Manvill Styles Limited

728 South Shyampur, Hemayetpur, Savar, Dhaka

23 March 2025

2. Observations:

Observation 2: Incomplete as-built drawings. (Building-1)

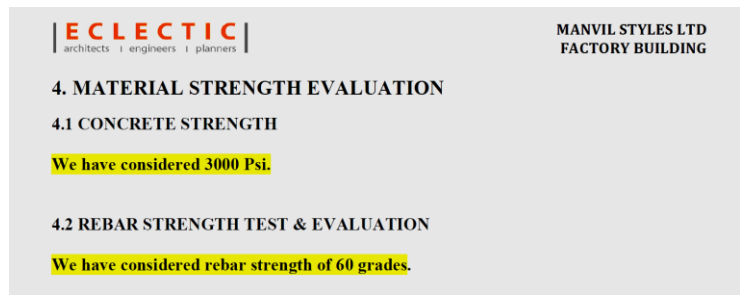
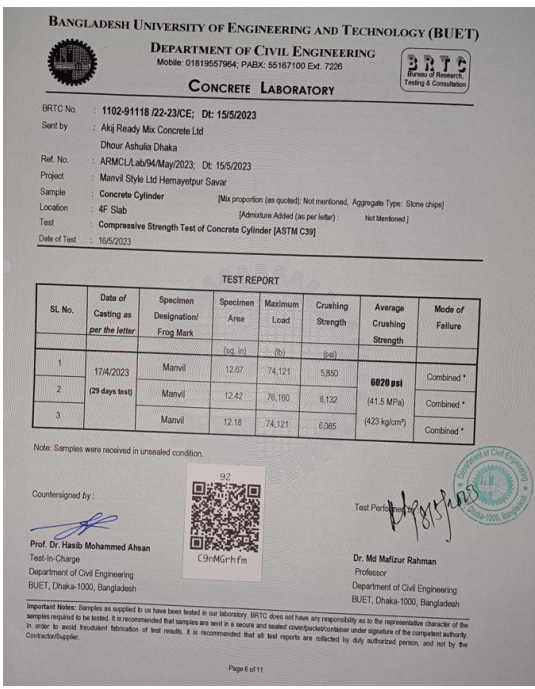
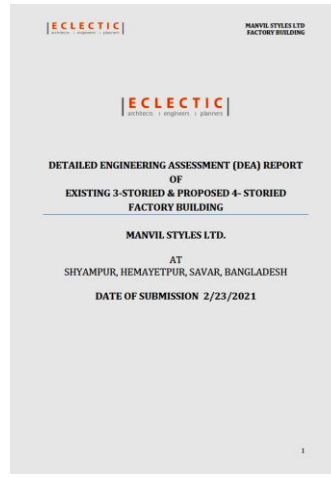
Roof shed

Built up in the toilet zone

Description: A set of as-built drawings was available for the RC part, where the floor layout did not match the existing condition. Extra concrete built up was found in the toilet zones. Moreover, no drawing was available for the roof shed. The building engineer is required to survey structures and prepare a full set of as-built drawings in compliance with section 1.9, part 6 of BNBC.

5.	Incomplete as-built drawings. (Building-1)	The building engineer is required to survey structures and prepare a full set of as-built drawings in compliance with section 1.9, part 6 of BNBC.	within 6 weeks

Observation 1: Inconsistencies in the assessment report. (Building-1)

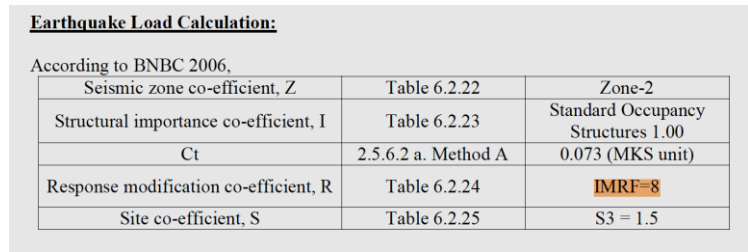
An inadequate number of concrete cylinder test reports were found on site to confirm the design strength of 3000 psi.

Response modification coefficient, R value considered as 8 for IMRF, but no calculation/justification is provided for the

Description: During the inspection, a detailed engineering assessment report was available onsite for the four-storied factory building. Where the building is currently five-storied, including the roof shed. Moreover, no live load plan was found prepared.

Item No	Observation	Action Plan	Timeline
1.	Inconsistencies in the assessment report. (Building-1)	Building engineer is required to address the inconsistencies in the design report and submit revised design documents to RSC to complete the review.	within 6 weeks

Observation 8: Lack of lateral stability and overstressed steel members in the assessment report. (Shed Building)

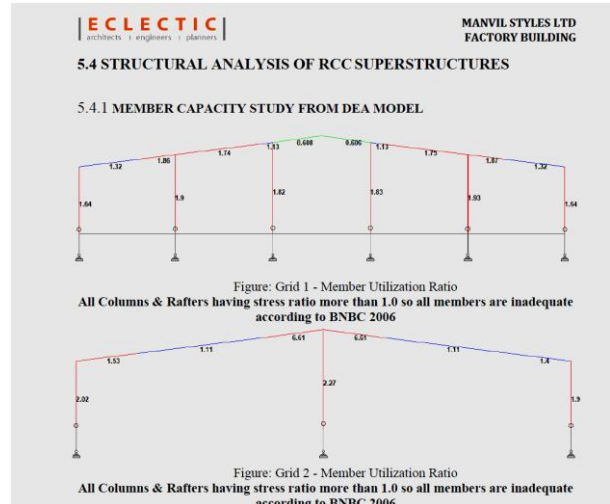
- All Steel Columns are inadequate according to BNBC 2006 load combination.
- All Steel Rafters are inadequate according to BNBC 2006 load combination.
- Structure is inadequate in Displacement.

Description: The shed building has no obvious lateral stability system (compression strut). A DEA report was available on site. As per the recommendation of the report, retrofitting was suggested, but no remediation work was found on-site.

Building engineer is required to update the design documents following BNBC for lateral stability and adequacy of structural members and submit to RSC.
